STATE OF CONNECTICUT
CONNECTICUT SITING COUNCIL

APPLICATION OF HOMELAND TOWERS, LLC
AND NEW CINGULAR WIRELESS PCS, LLC d/b/a
AT&T FOR A CERTIFICATE OF
ENVIRONMENTAL COMPATIBILITY AND
PUBLIC NEED FOR THE CONSTRUCTION,
MAINTENANCE, AND OPERATION OF A
TELECOMMUNICATIONS FACILITY AT
183 SOUNDVIEW LANE, TOWN OF NEW
CANAAN, CONNECTICUT

DOCKET NO. 487

HOMELAND TOWERS, LLC and NEW CINGULAR WIRELESS PCS, LL (AT&T)
RESPONSES TO SITING COUNCIL PRE-HEARING INTERROGATORIES
SET TWO

Aerial Map of Homeland Towers search and proposed site with a 3/4 mile radius search ring

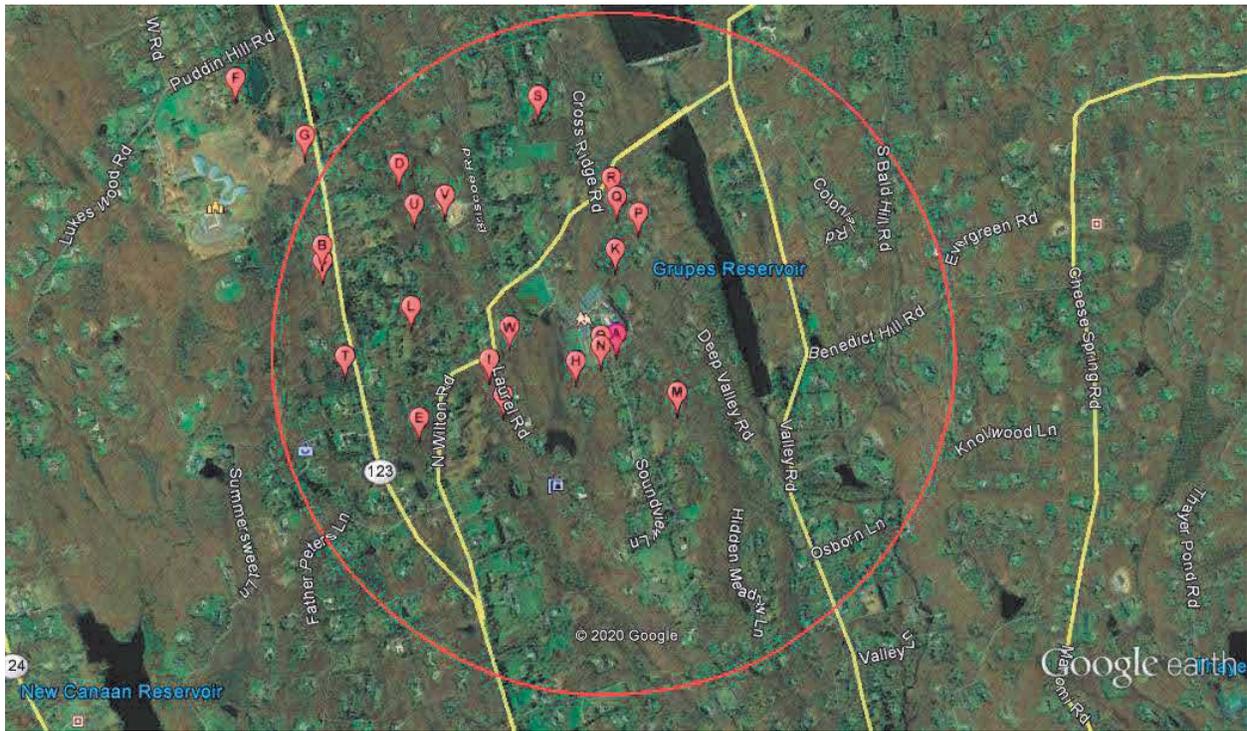
- Q40. Referencing the Applicants' response to Council interrogatory 20, the search ring is a circle with a 3/4-mile radius and centered at the proposed site. Referencing Tab 2 of the Application, Properties Investigated by Homeland Towers, the Applicants note that Homeland Towers, LLC (Homeland) investigated 23 sites "in and around the New Canaan search area." Provide an updated and expanded view of Application Tab 2, Figure 1 (Aerial Map of Homeland Towers Search and Proposed Site) with a 3/4-mile radius search ring circle depicted and centered on the proposed site.

- A40. *Please see the updated Aerial Map of Homeland Towers Search and Proposed Site with a 3/4 mile radius search ring circle depicted and centered on the proposed site included in Attachment 2.*

Existing & Alternate
 700 MHz LTE Coverage

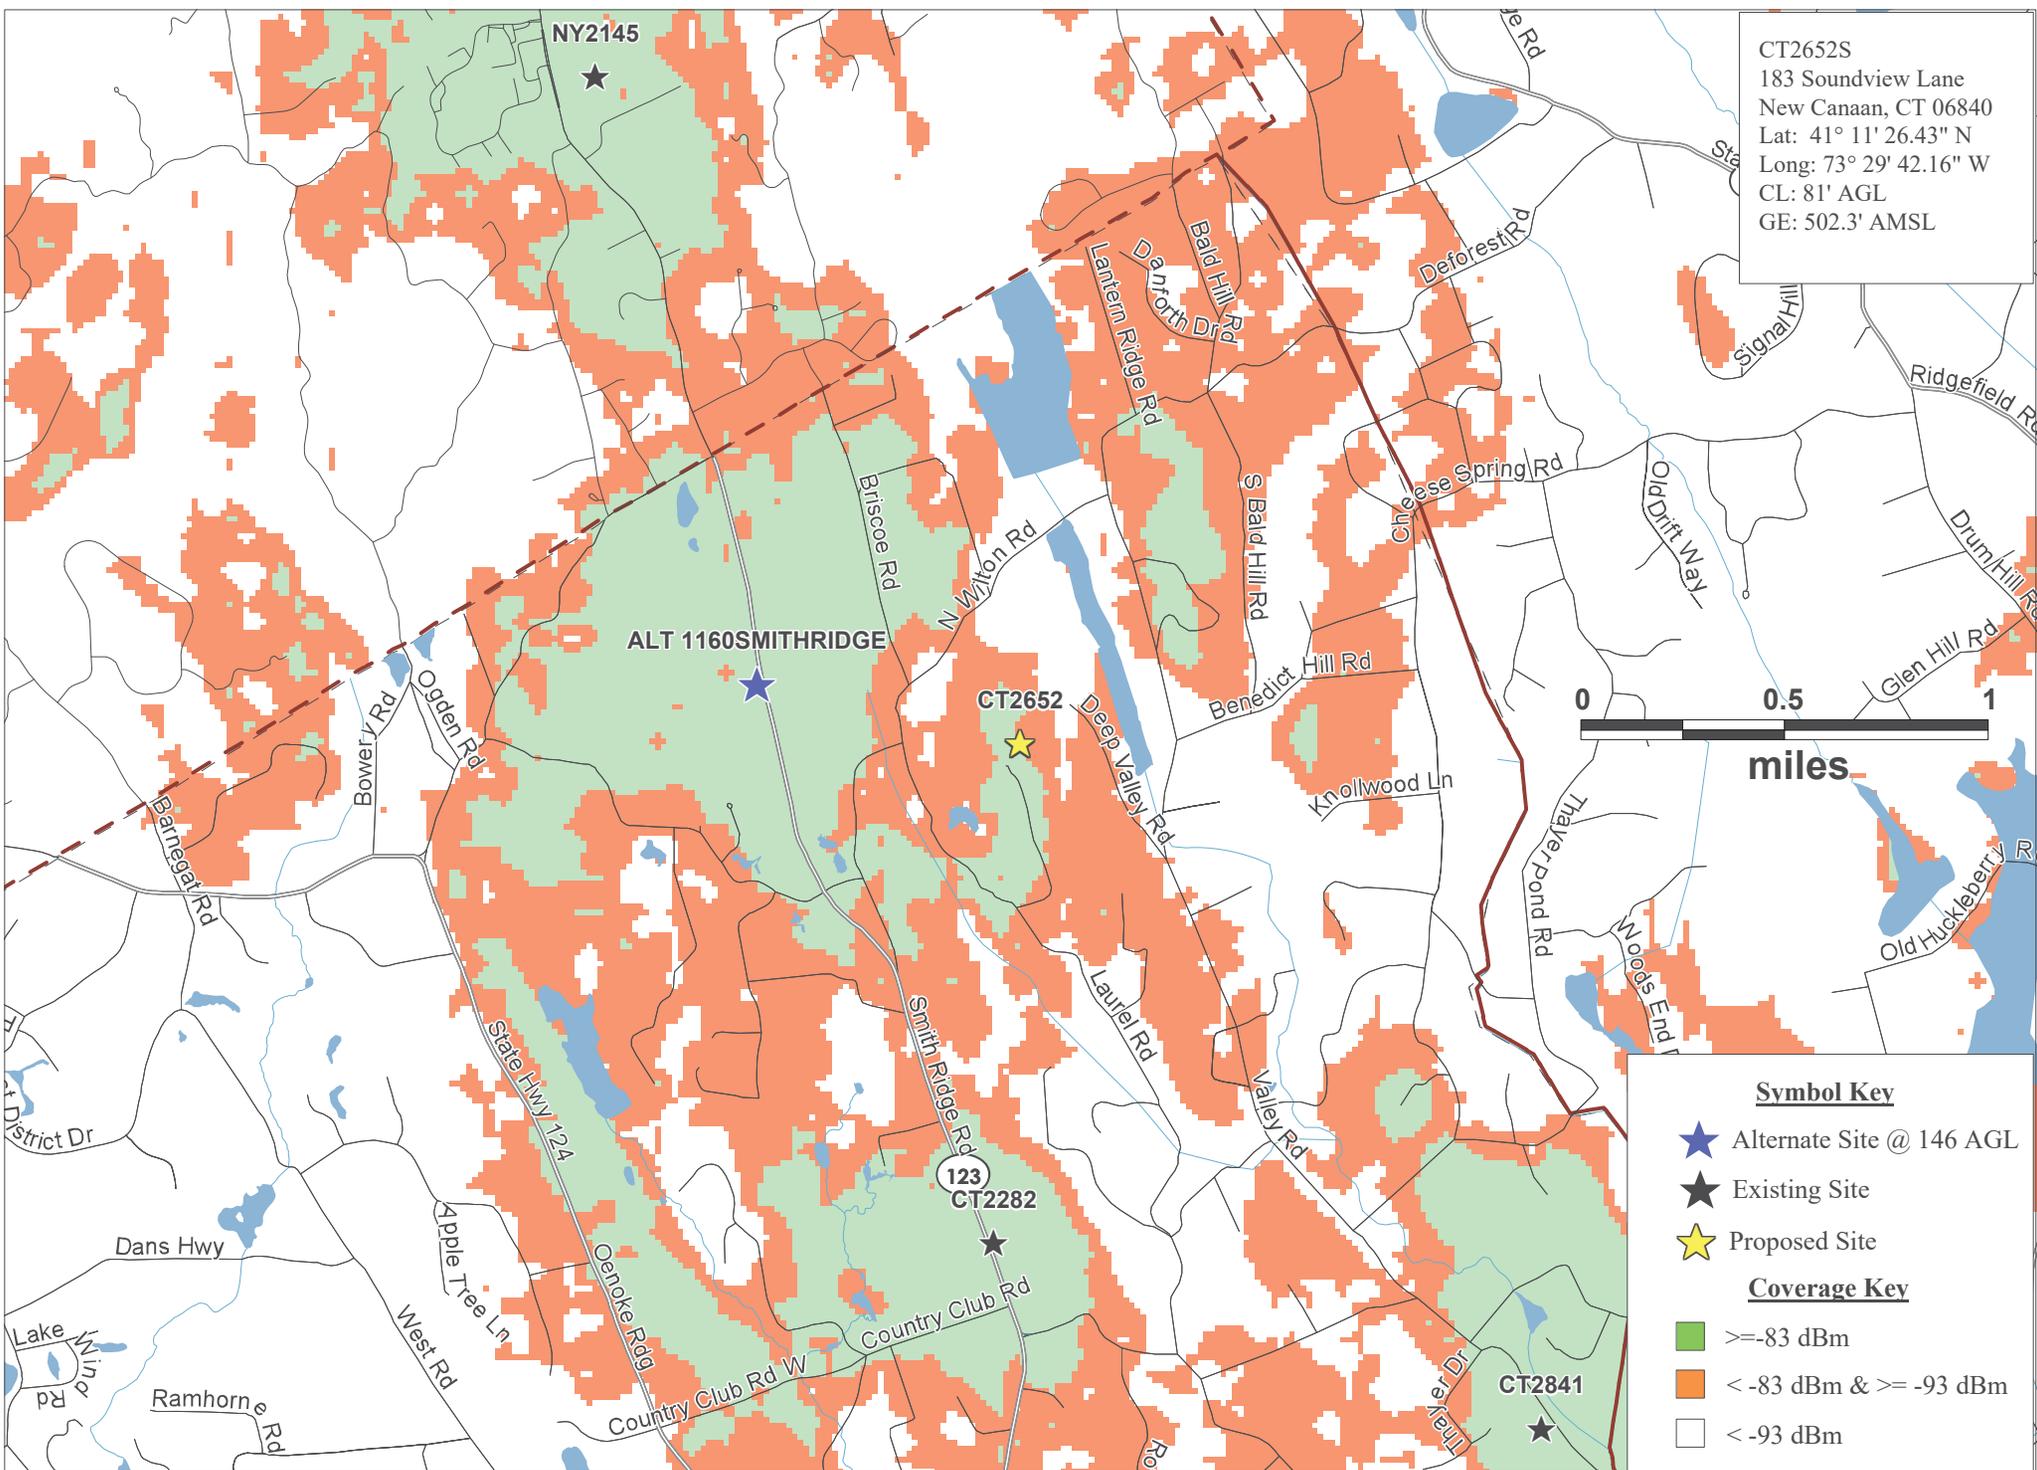
- Q41. Referencing the Applicants' response to Wiley interrogatory 29, explain why AT&T's radio frequency engineers determined that a tower facility at 1160 Smith Ridge Road would not provide service to the area intended to be covered by the proposed facility.

- A41. *The tower facility at 1160 Smith Ridge Road would not provide coverage to the area intended for coverage by the Proposed Facility because this site is too far west. The propagation map included in Attachment 3 shows the coverage from a 146' tall tower facility at 1160 Smith Ridge Road and demonstrates that it would not provide adequate service to the intended service area.*

PHOTO LOG

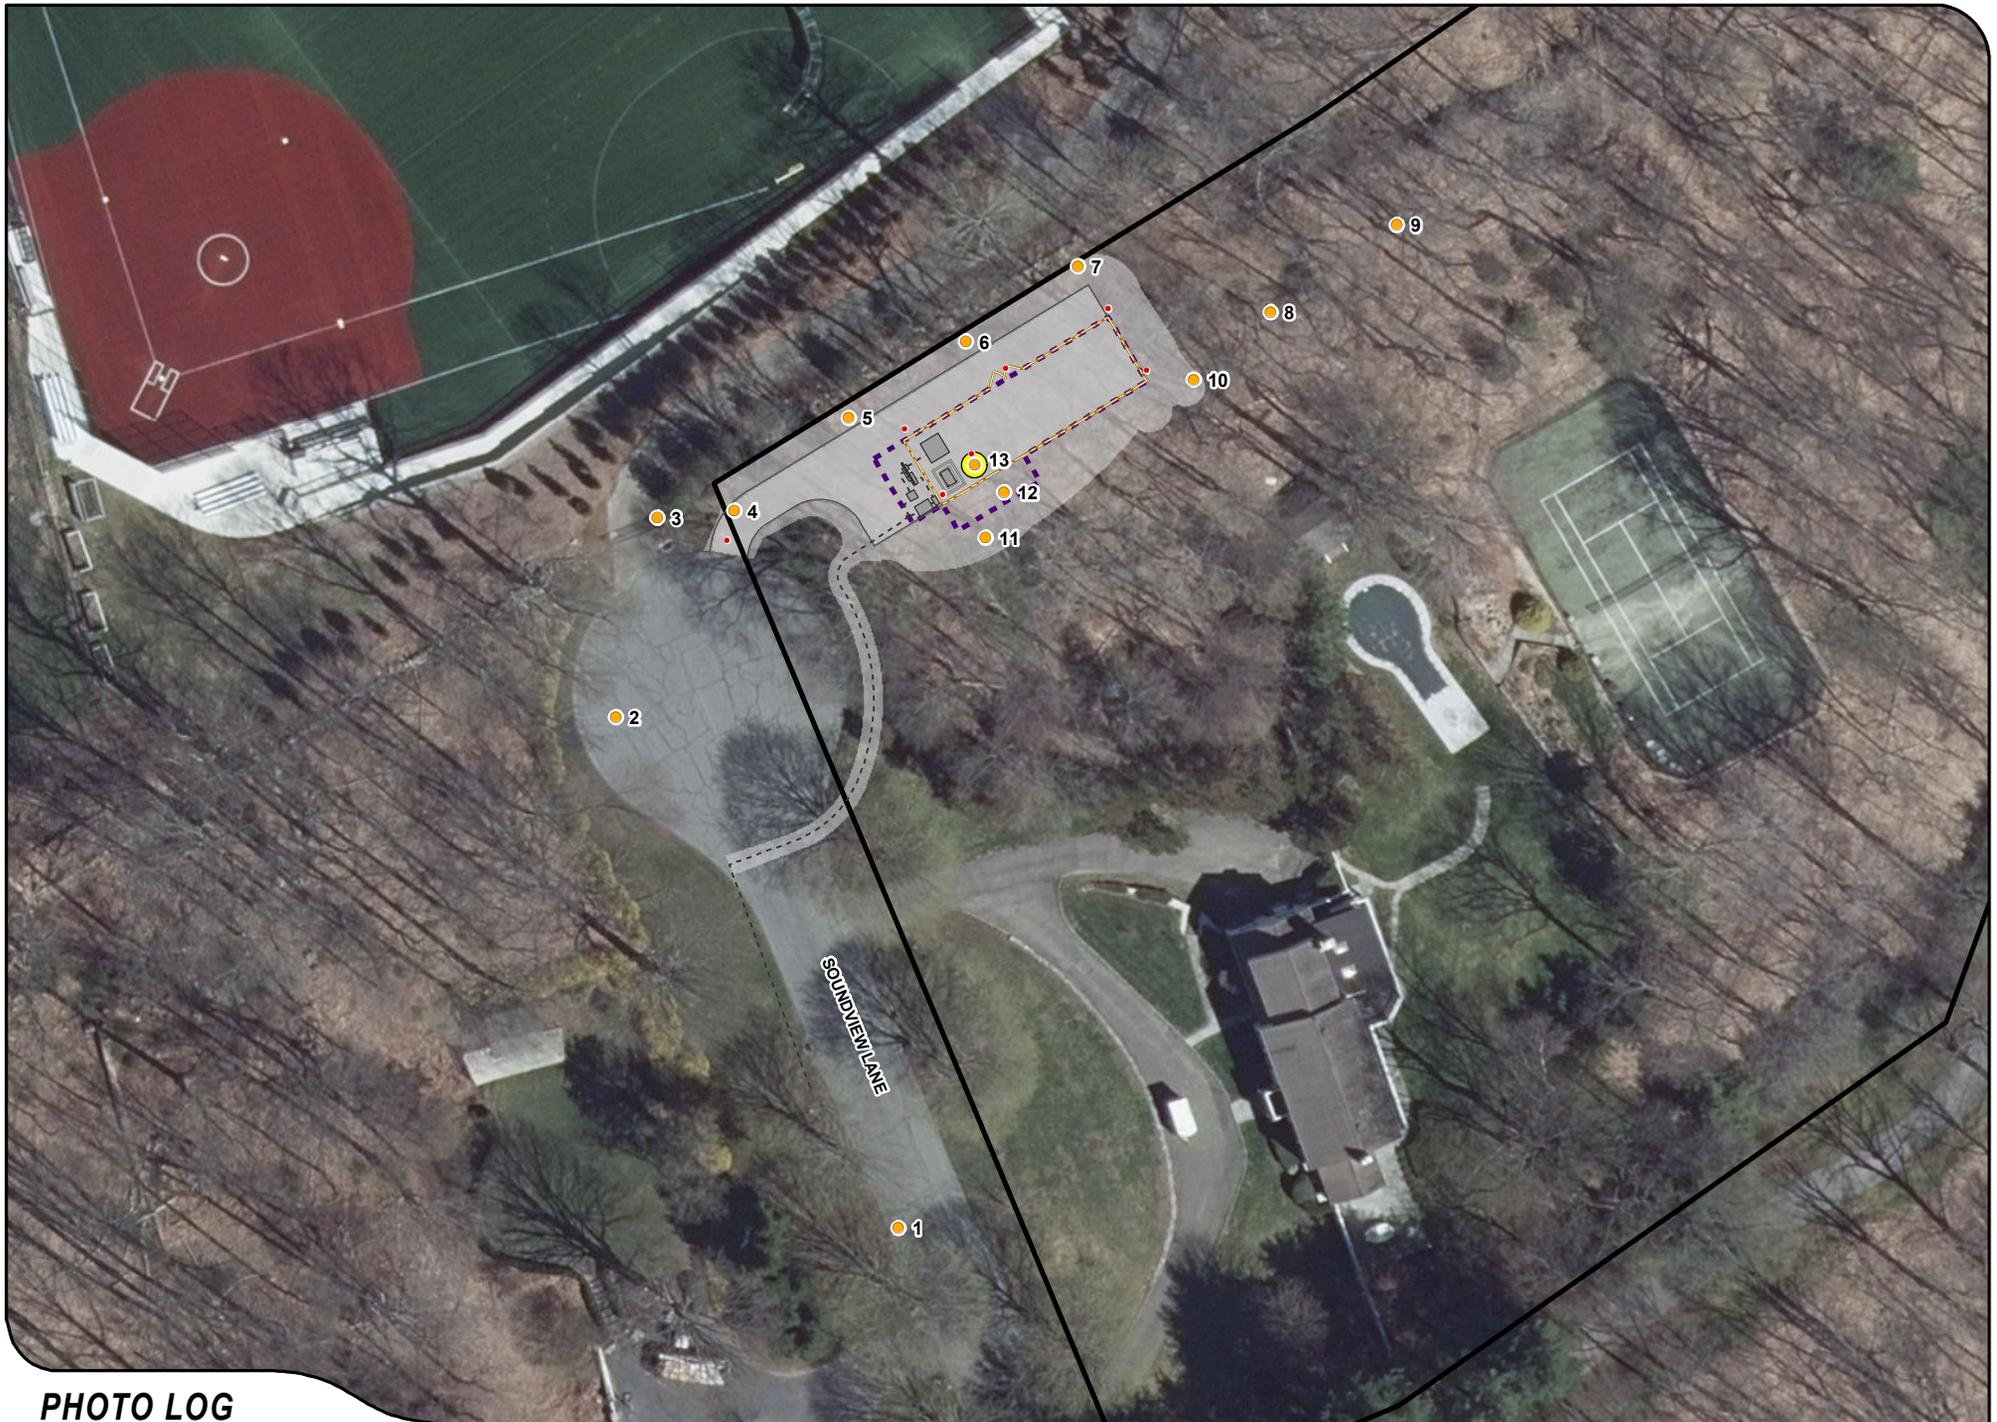
Q53. Please submit photographic site documentation with notations linked to the site plans or a detailed aerial image that identify locations of site-specific and representative site features. The submission should include photographs of the site from public road(s) or publicly accessible area(s) as well as Site-specific locations depicting site features including, but not necessarily limited to, the following locations as applicable:

For each photo, please indicate the photo viewpoint direction and stake or flag the locations of site-specific and representative site features. Site-specific and representative site features include, but are not limited to, as applicable:

A photolog graphic must accompany the submission, using a site plan or a detailed aerial image, depicting each numbered photograph for reference. For each photo, indicate the photo location number and viewpoint direction, and clearly identify the locations of site-specific and representative site features shown (e.g., physical staking/flagging or other means of marking the subject area).

A53. *Please see the Remote Field Review photo documentation report in Attachment 5.*
